**RE: REQUEST TO AMEND DEVELOPMENT APPLICATION AND RESPONSE TO REQUEST FOR
ADDITIONAL INFORMATION- DA22/1172**

PROPERTY AT 657-767 MAMRE ROAD, KEMPS CREEK (LOT 10 APPROVED UNDER SSD 9522)

Proposed Amendments to DA22/1172

Future Lot 14, 657-769 Mamre Road, Kemps Creek

Figure 2: SLR Overlay (Source: Altis Frasers JV, 2023)

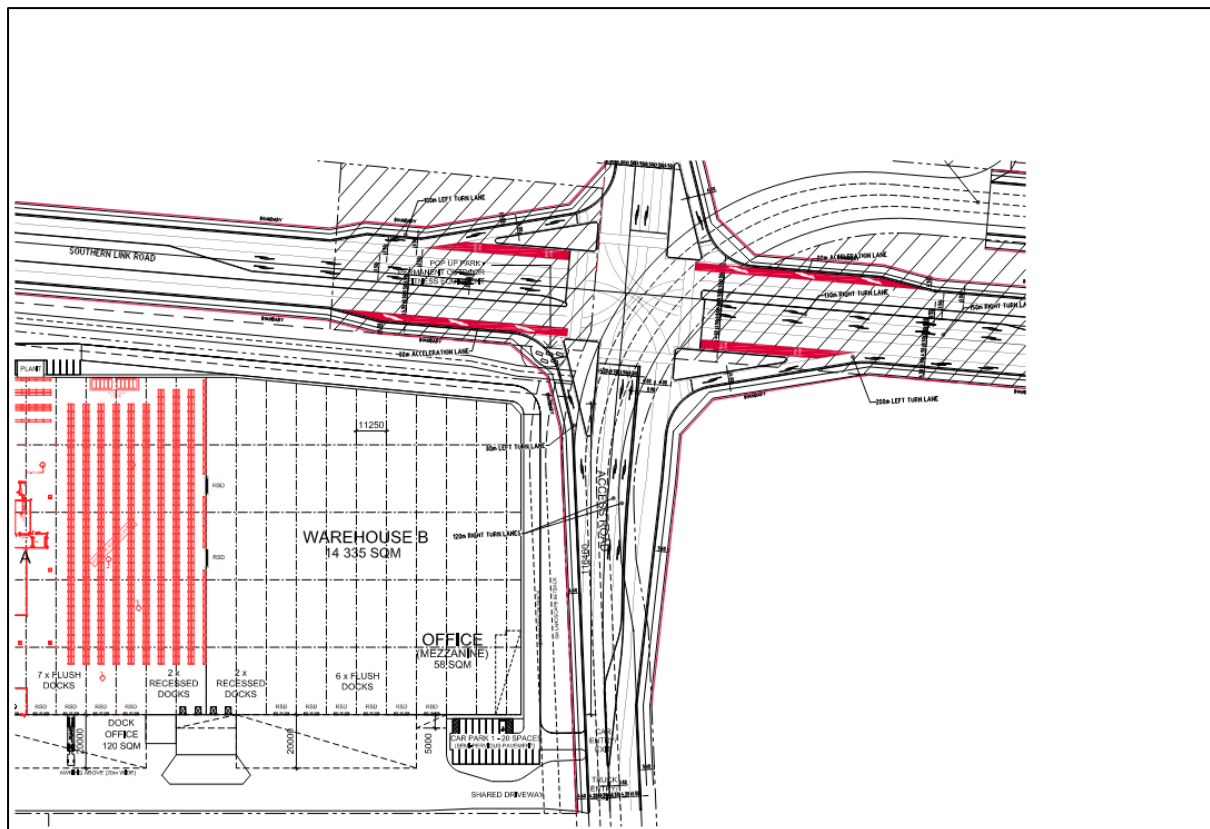
Upon further investigation, potential conflicts between the Open Space Edge Road, the approved road network design under **SSD-9522**, and the future Southern Link Road intersection have been identified.

The investigations have concluded that the future alignment of the Open Space Edge Road, if constructed, would conflict with the future left turn slip lane from the North-South Collector Industrial Road, northbound to the SLR WB lane. Accordingly, Ason Group have advised that the full extent of the Open Space Edge Road must end at the proposed turning head.

Figure 2 below illustrates the potential conflict should the full extent of the Open Space Edge Road be constructed.

As such, a meeting with Council was held to raise these issues and propose that a portion of the Open Space Edge Road be relocated and replaced with a shared pedestrian and cycle pathway.

Figure 3: Proposed Amended Site Plan (Source: HLA Architects, 2023)

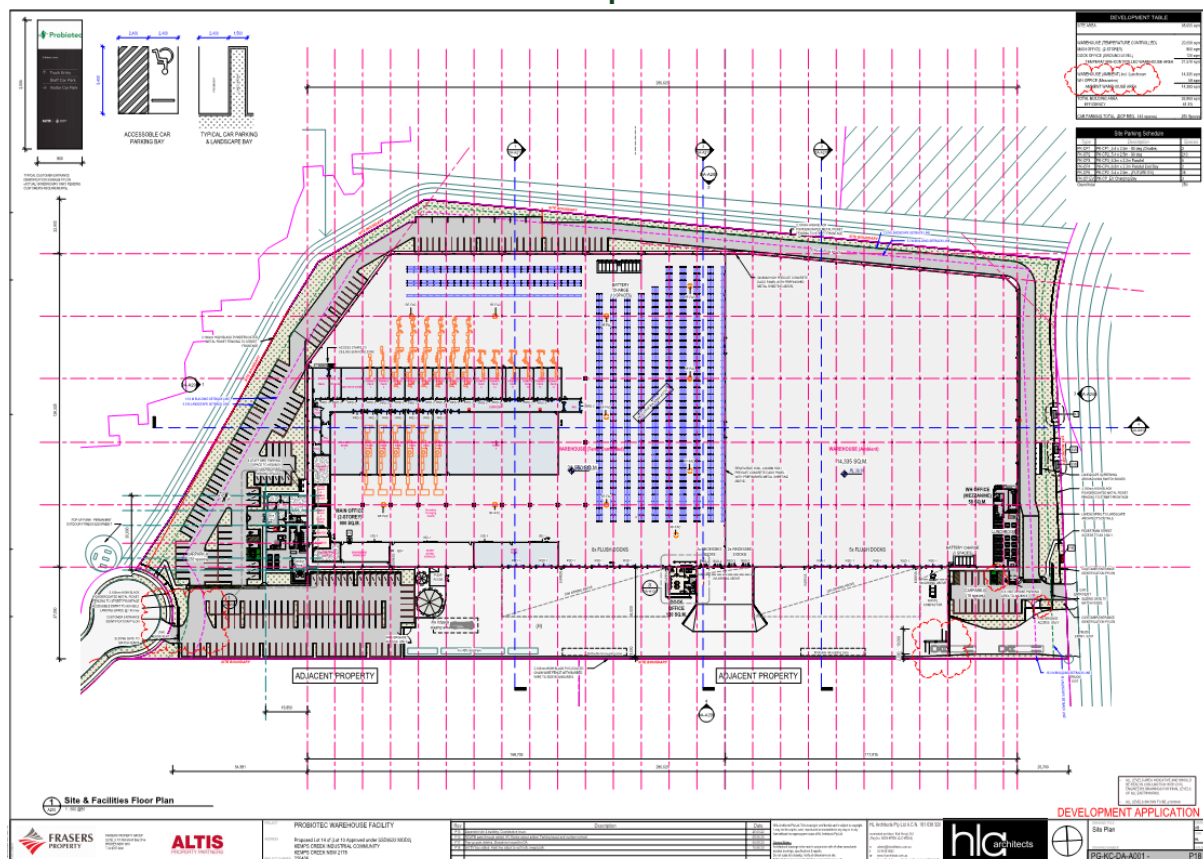
The proposed amendments include the expansion of the Warehouse and Distribution Centre as a result of the surplus industrial zoned land provided by the relocation of the Open Space Edge Road to within the RE1 Public Recreation zoned land. The proposed amendment has been designed with consideration to the MRPDGP and the additional requests provided by Council within their RFI. Further details are provided within **Section 5.3** and **Section 4** of this Statement.

Detailed Architectural Plans, illustrating the proposed amendments requested above, accompany this letter as **Appendix 1**, an excerpt of which is provided within **Figure 3** below.

Figure 4: Shared Path (Source: Habit8, 2023)

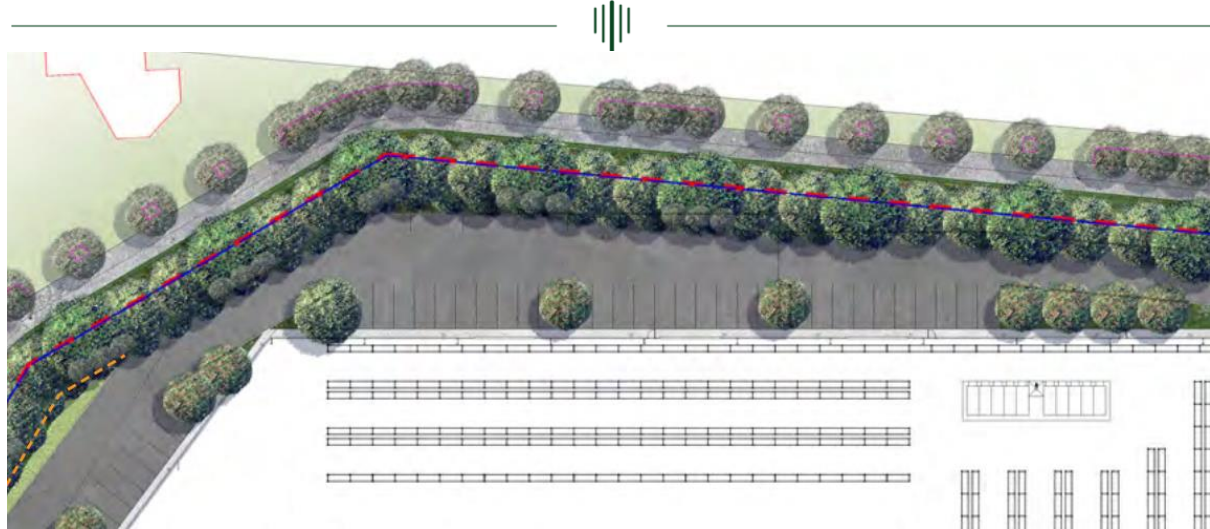
The proposed amendments include the relocation of a section of the Open Space Edge Road to within the RE1 Public Recreation zoned land and replacement with a shared pedestrian and cycle pathway. The pathway will provide an accessible and well-landscaped path and will encourage bicycle usage within the Mamre Road Precinct, aligning with the objectives of the MRPDGP.

The shared pathway has been proposed as a result of the relocation of the Open Space Edge Road within RE1 Public Recreation zoned land, whilst also ensuring accessibility is still provided for emergency and maintenance vehicles. The proposed amendments will also include a pocket park at the southwest section of the Subject Site which will include exercise equipment.

The Shared Path and Pocket Park are illustrated in **Figure 4** and **Figure 5** below.

Figure 6: Subdivision Plan (Source: HLA Architects, 2023)

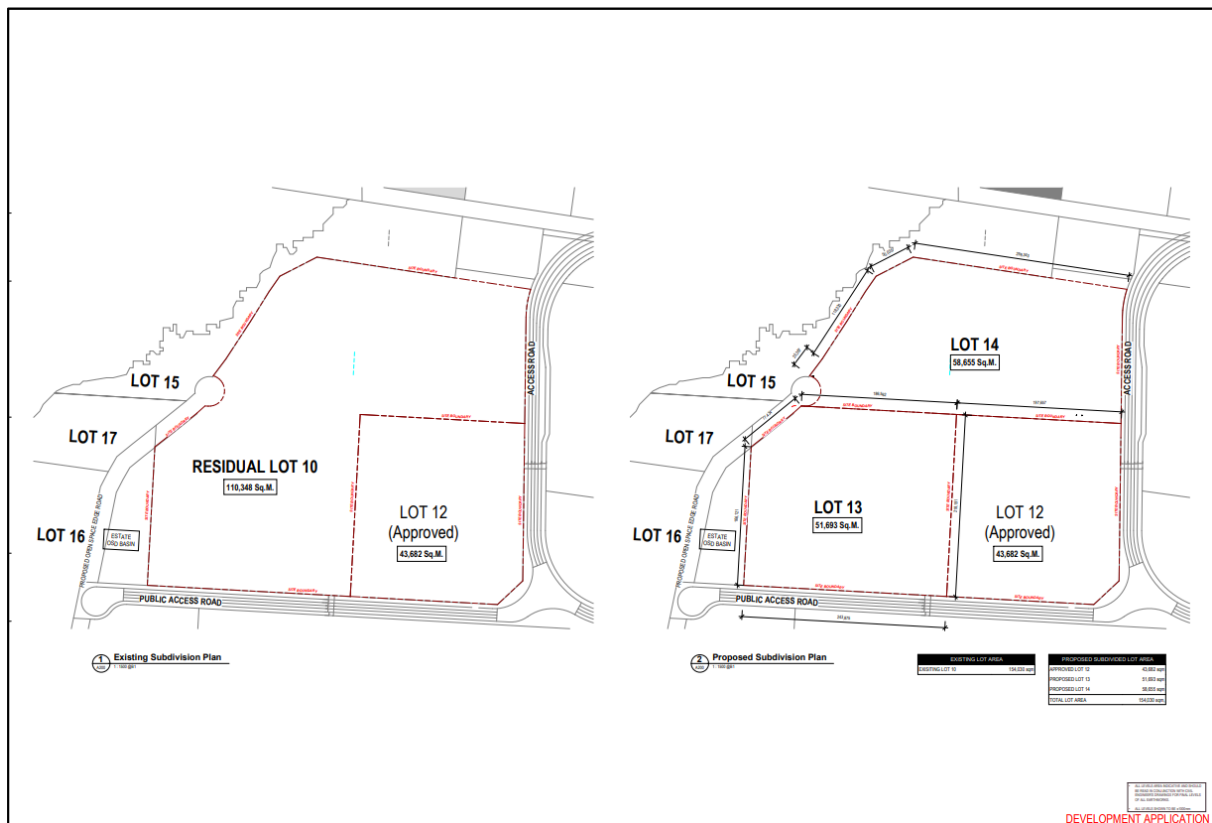
The proposed amendments include the expansion of the currently subdivided lot as a result of the removal of the Open Space Edge Road. Specifically, **DA22/0671** granted Development Consent for the two (2) lot Torrens Title subdivision of Lot 10 approved under **SSD-9522 MOD 2** into Lot 13 (Residual Site) and Lot 14 (Development Site).

This amendment seeks to increase the size of Lot 14 by 8,421m² resulting in a total lot size of 58,655m².

The proposed amendment to the subdivision is provided within **Figure 6** below.
